Architectural Review Board

Meeting Minutes

November 14, 2018

**CERTIFICATE OF APPROPRIATENESS AND WAIVERS
24 E. MAIN STREET**

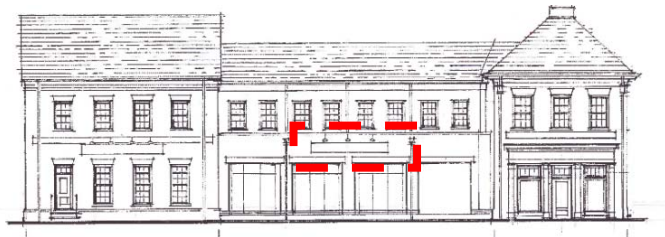
The proposed wall sign is an appropriate sign type for this tenant space and is consistent with the other wall signs and within the Market Square area in terms of location and design. This smaller sign size appears to be appropriately scaled for the Farmers Alley elevation.
